2252 TOWER ROAD  
 2252 TOWER ROAD  
 AURORA, ADAMS COUNTY, COLORADO

**PROPOSED DRAINAGE AREA MAP**

DESIGNED:	DD	DATE:	OCTOBER 2022	PROJECT #:	22-006	SHEET:	C5.1
DRAWN:	DD	DATE:	OCTOBER 2022	PROJECT #:	22-006	SHEET:	C5.1
REVIEWER:	MG	DATE:	OCTOBER 2022	PROJECT #:	22-006	SHEET:	C5.1

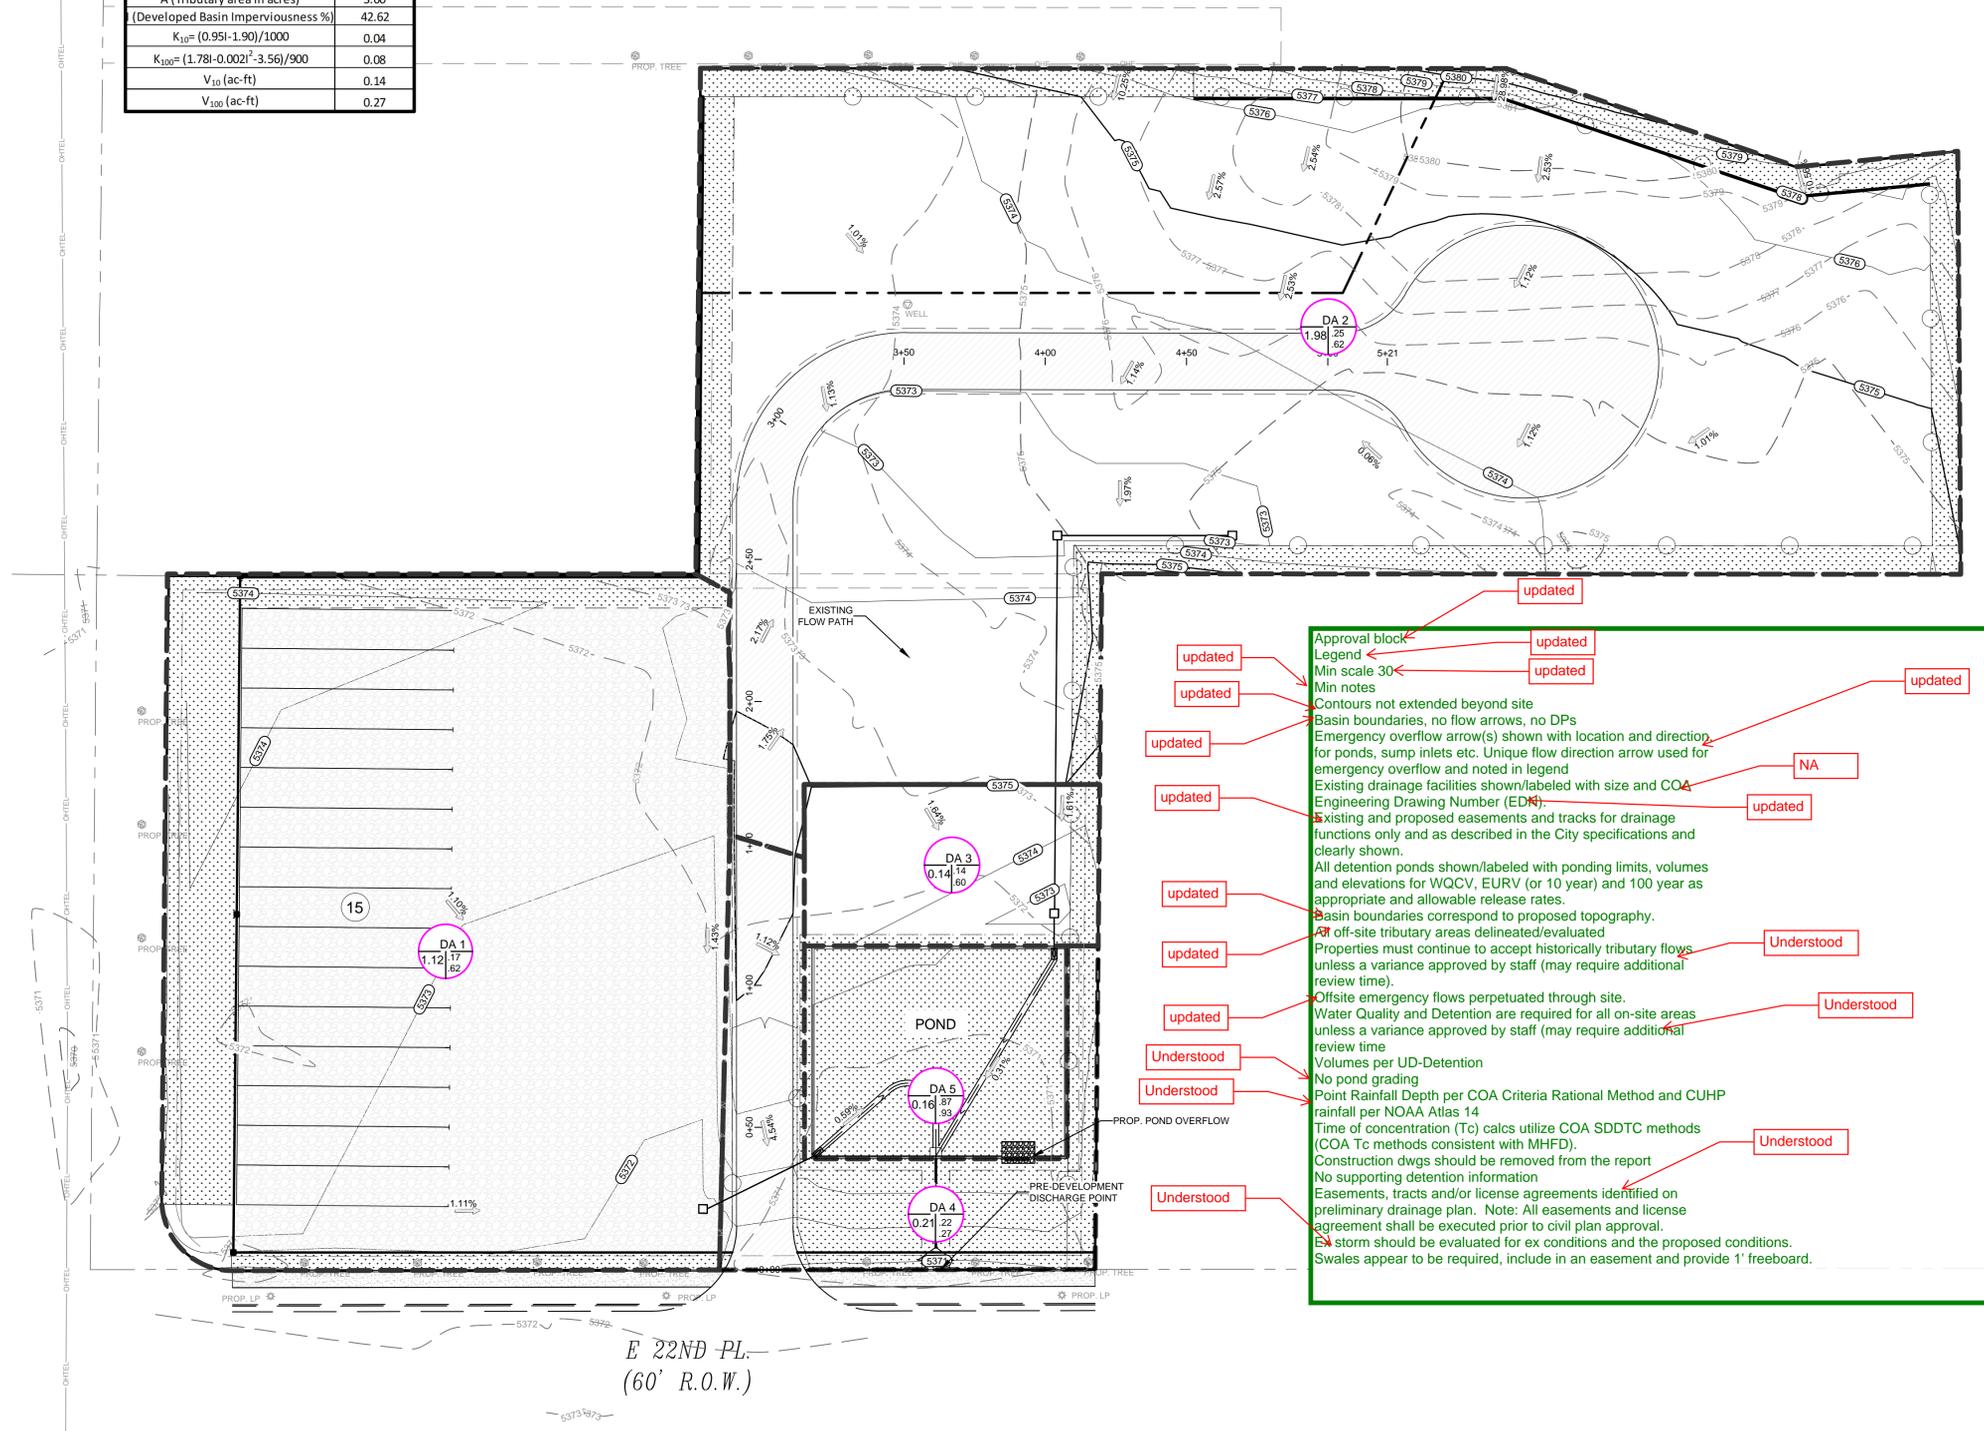
Approval block updated  
 Legend updated  
 Min scale 30 updated  
 Min notes updated  
 Contours not extended beyond site updated  
 Basin boundaries, no flow arrows, no DPs updated  
 Emergency overflow arrow(s) shown with location and direction for ponds, sump inlets etc. Unique flow direction arrow used for emergency overflow and noted in legend updated  
 Existing drainage facilities shown/labelled with size and COA updated  
 Engineering Drawing Number (EDN) updated  
 Existing and proposed easements and tracks for drainage functions only and as described in the City specifications and clearly shown. updated  
 All detention ponds shown/labelled with ponding limits, volumes and elevations for WQCV, EURV (or 10 year) and 100 year as appropriate and allowable release rates. updated  
 Basin boundaries correspond to proposed topography. updated  
 At off-site tributary areas delineated/evaluated updated

Properties must continue to accept historically tributary flows unless a variance approved by staff (may require additional review time). Understood  
 Offsite emergency flows perpetuated through site. updated  
 Water Quality and Detention are required for all on-site areas unless a variance approved by staff (may require additional review time) Understood  
 Volumes per UD-Detention Understood  
 No pond grading Understood  
 Point Rainfall Depth per COA Criteria Rational Method and CUHP rainfall per NOAA Atlas 14 Understood  
 Time of concentration (Tc) calcs utilize COA SDDTC methods (COA Tc methods consistent with MHFD). Understood  
 Construction dwgs should be removed from the report  
 No supporting detention information  
 Easements, tracts and/or license agreements identified on preliminary drainage plan. Note: All easements and license agreement shall be executed prior to civil plan approval.

A storm should be evaluated for ex conditions and the proposed conditions.  
 Swales appear to be required, include in an easement and provide 1' freeboard.
